BID ADDENDUM NO. 1

Project Name: Raccoon Town
Owner: Port Gamble S'Klallam Tribe
Engineer of Record: Pat Fuhrer, P.E. – MAP Ltd

Addendum Date: April 2, 2026
Bid Due Date Unchanged: 12:00 pm April 15, 2026

C - 10.06

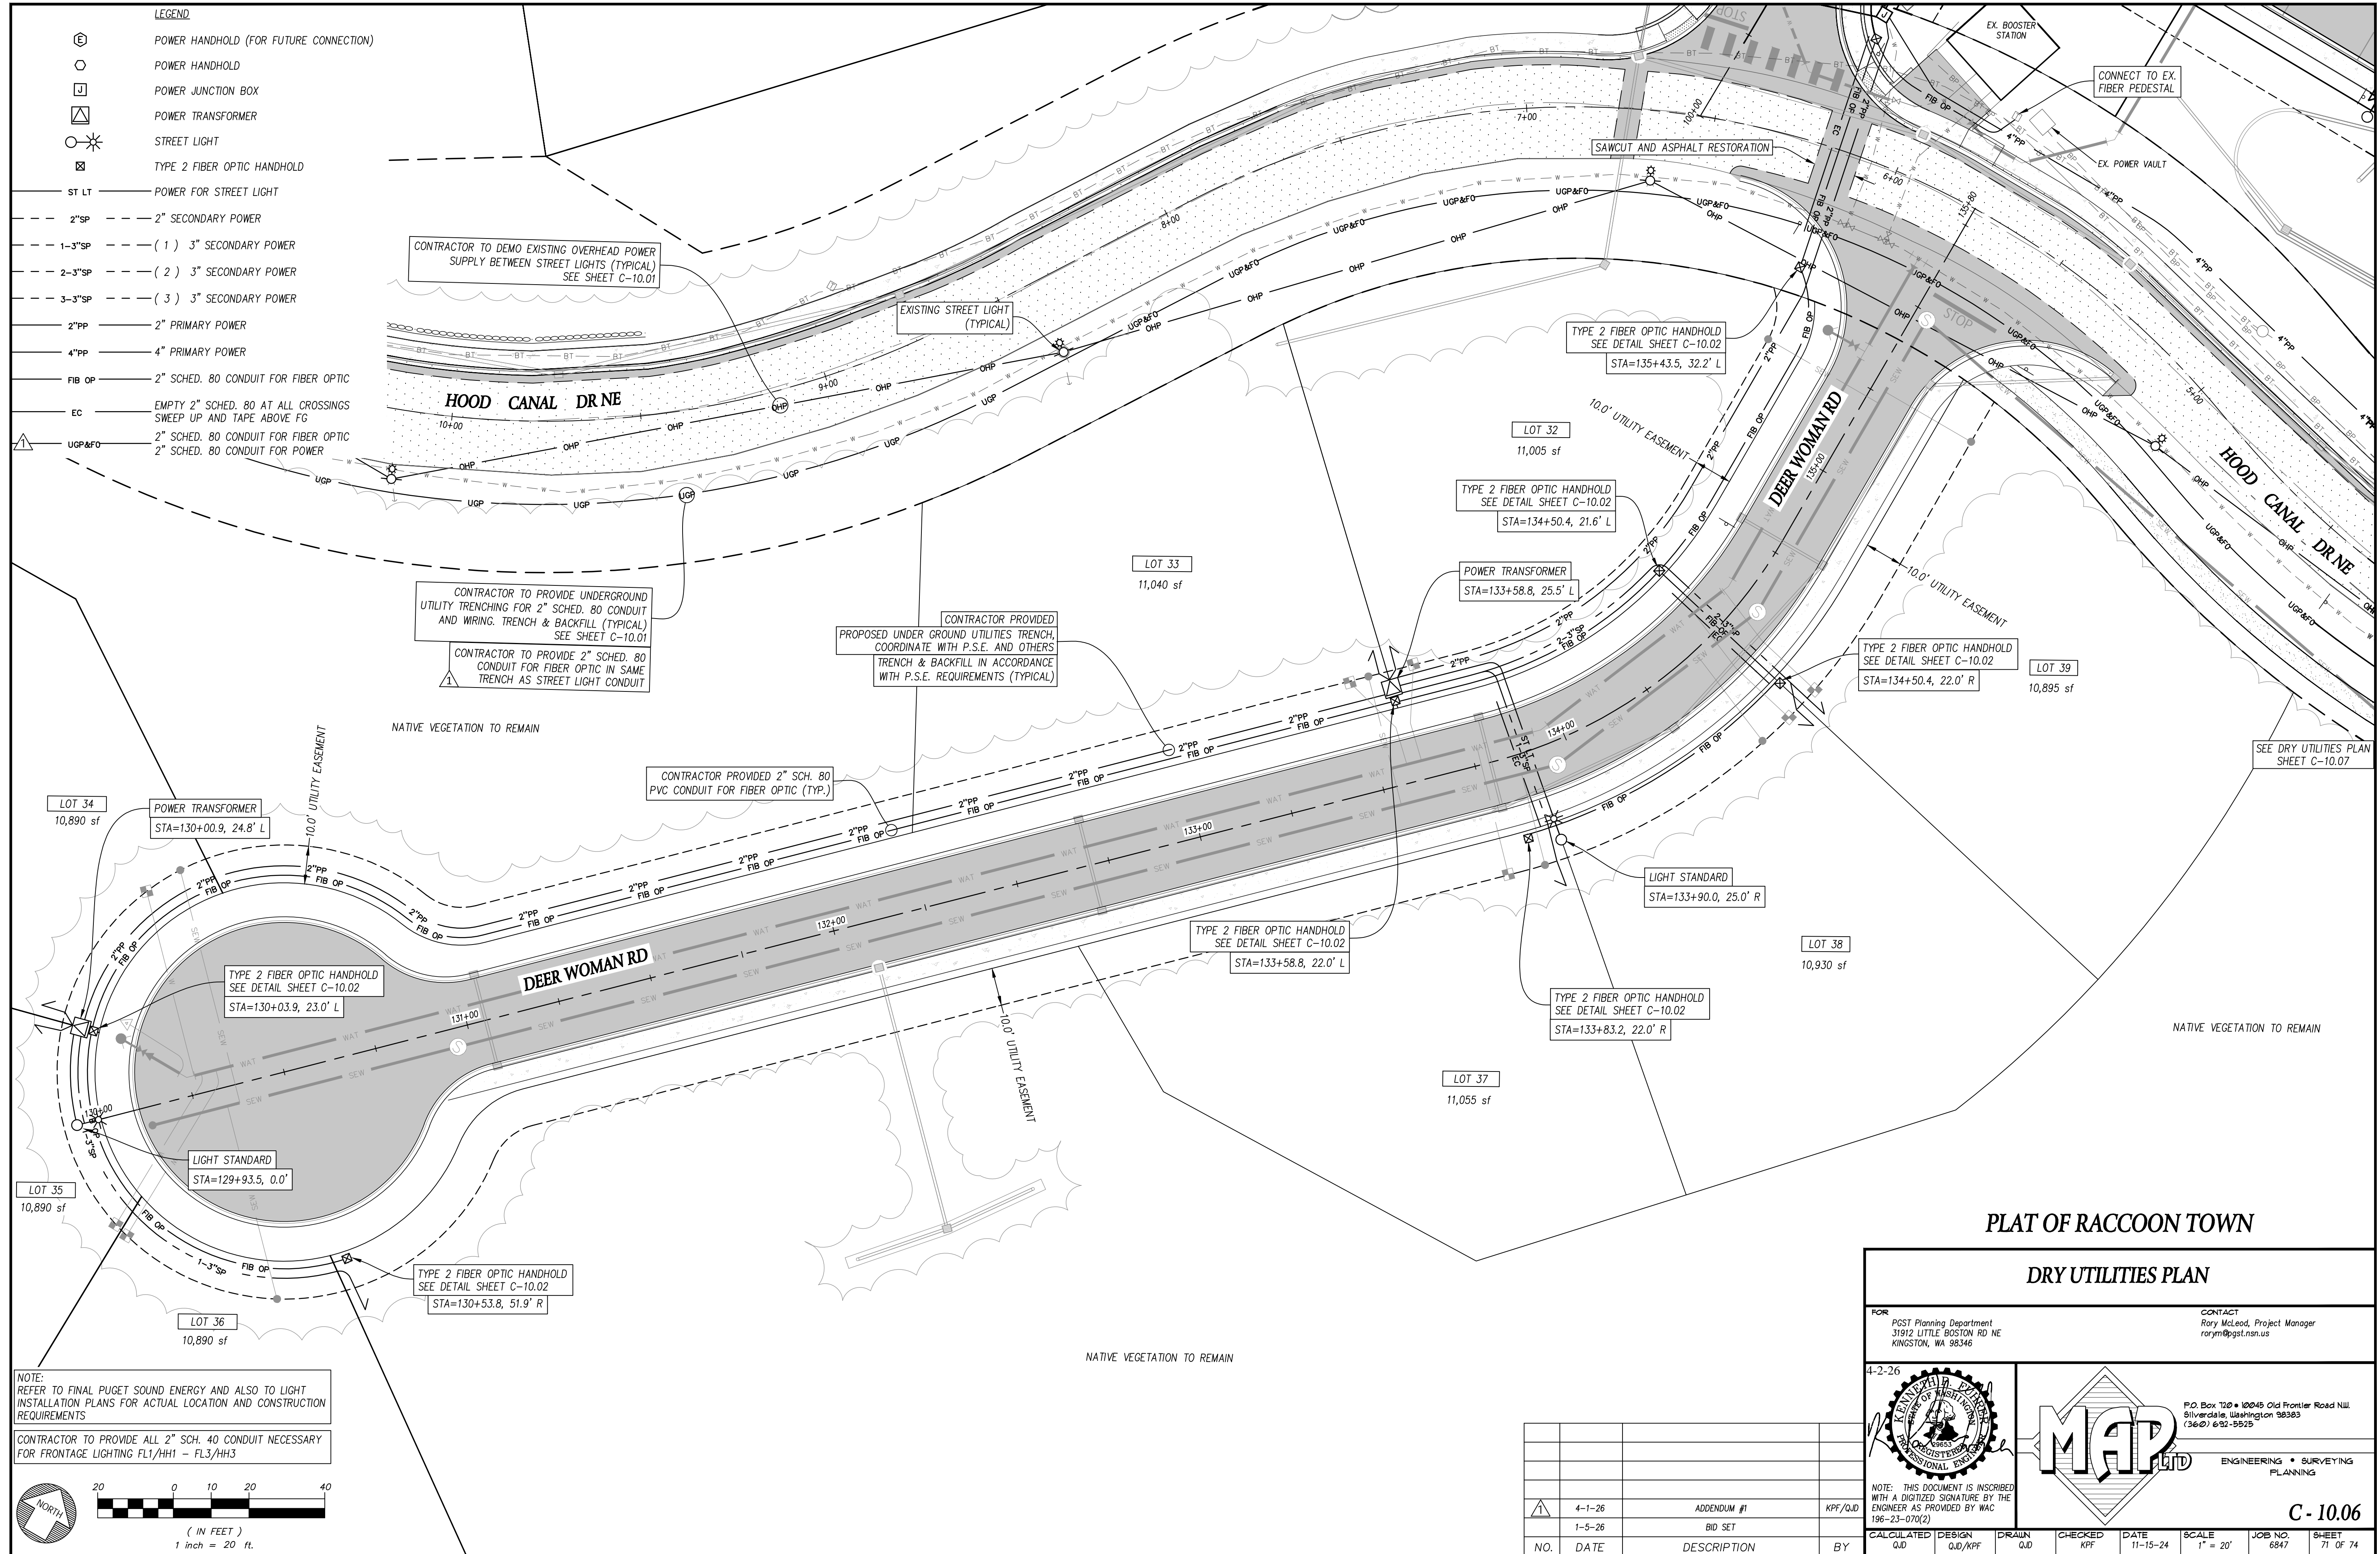
Please insert the attached revised plan sheets C-10.01, C-10.04, C-10.05, C-10.06, and C-10.07 dated 4-1-26 and sealed 4-2-26 into the bid set plans. These sheets were updated to include the Owner's request at the pre-construction meeting to **ADD** a second conduit and handholds to the street light trench for the Owner to install a fiber line. Also, a note was **ADDED** to clarify that the intent that the Contractor is responsible for re-energizing the Owner's street lights in Hood Canal Drive after undergrounding the conduit and pulling the new street light wire.

CONTRACTOR TO PROVIDE ALL 2" SCH. 40 CONDUIT NECESSARY
FOR FRONTAGE LIGHTING FL1/HH1 - FL3/HH3

C-10.07

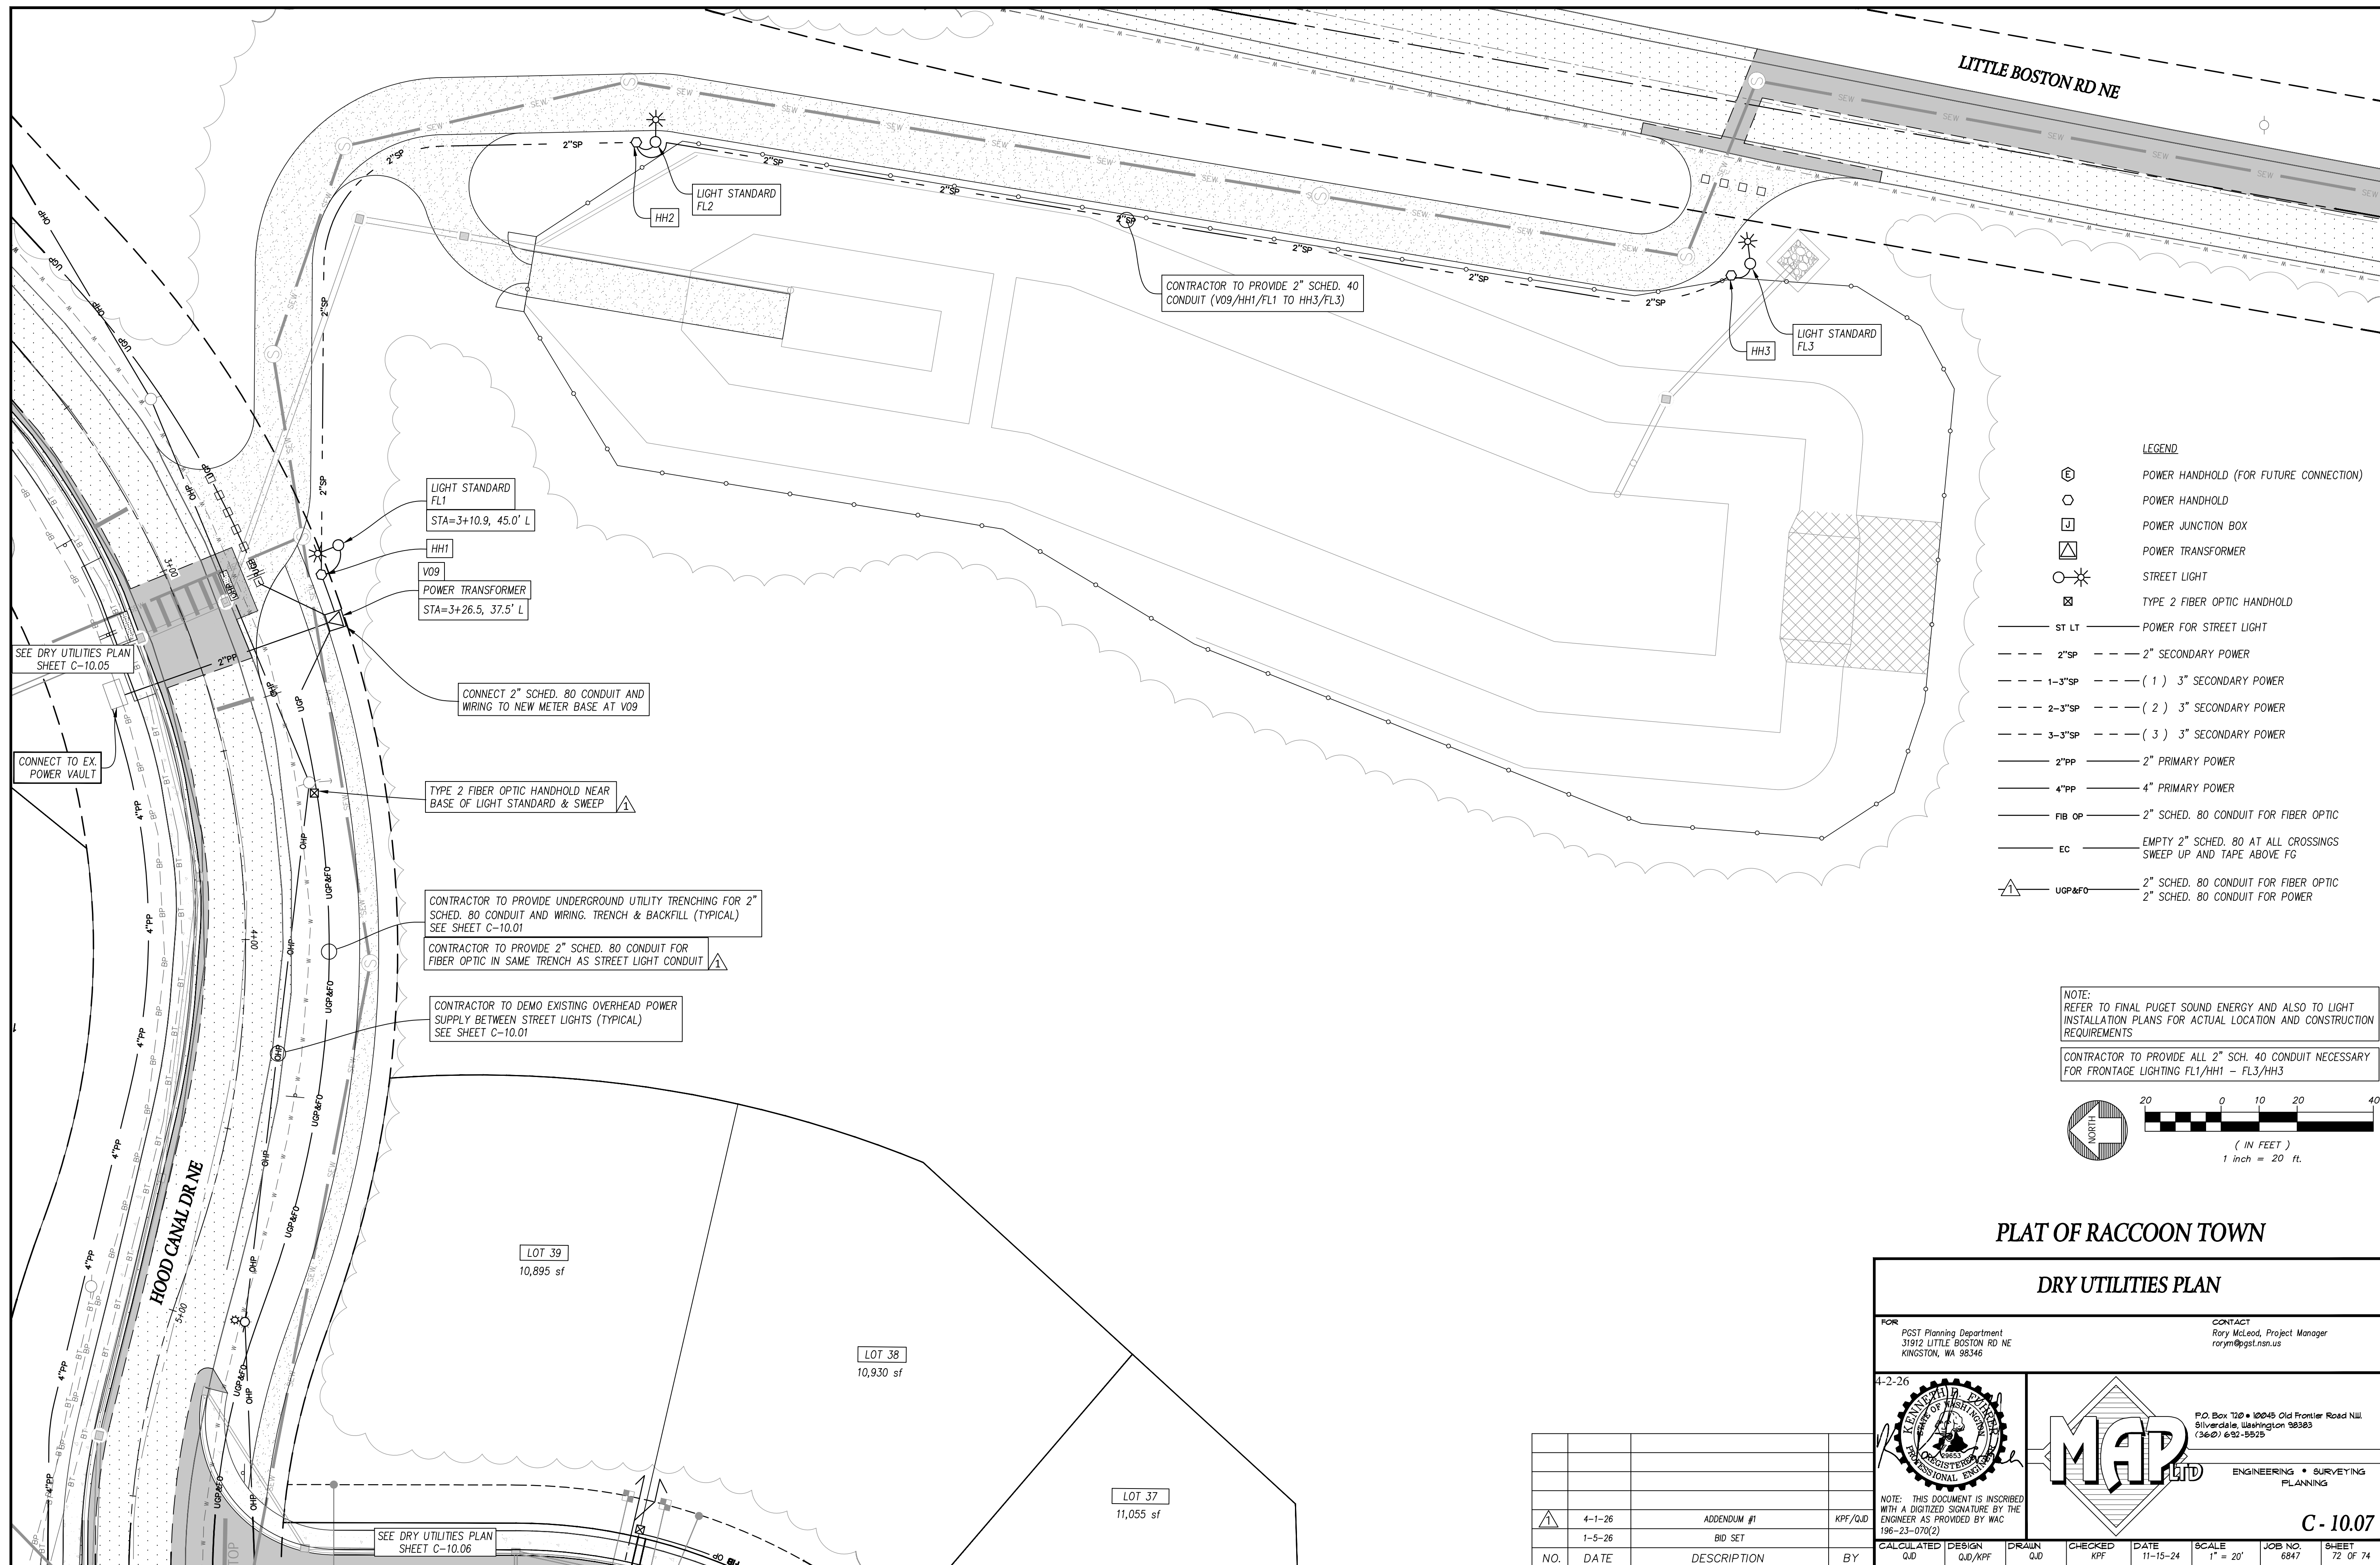
CONTRACTOR TO PROVIDE 2" SCHED. 40 CONDUIT (V09/HH1/FL1 TO HH3/FL3)

CONNECT 2" SCHED. 80 CONDUIT AND WIRING TO NEW METER BASE AT V09

CONTRACTOR TO PROVIDE UNDERGROUND UTILITY TRENCHING FOR 2" SCHED. 80 CONDUIT AND WIRING. TRENCH & BACKFILL (TYPICAL) SEE SHEET C-10.01

CONTRACTOR TO PROVIDE 2" SCHED. 80 CONDUIT FOR FIBER OPTIC IN SAME TRENCH AS STREET LIGHT CONDUIT

CONTRACTOR TO DEMO EXISTING OVERHEAD POWER SUPPLY BETWEEN STREET LIGHTS (TYPICAL) SEE SHEET C-10.01

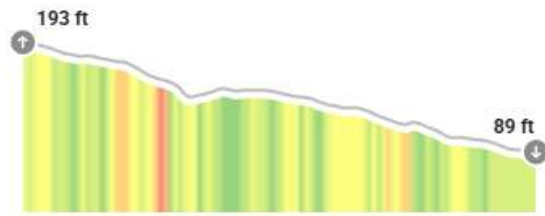
Can you confirm the location of the designated site area for the 25% volume of timber that is to be salvaged and given to the Tribe upon completion of the site clearing? **Attached please find an aerial photo of the Log laydown area, the driveway access lies on the east side of Little Boston Road just south of the Skate Park approximately 3/4-mile south of the Hood Canal Drive/Little Boston intersection.**
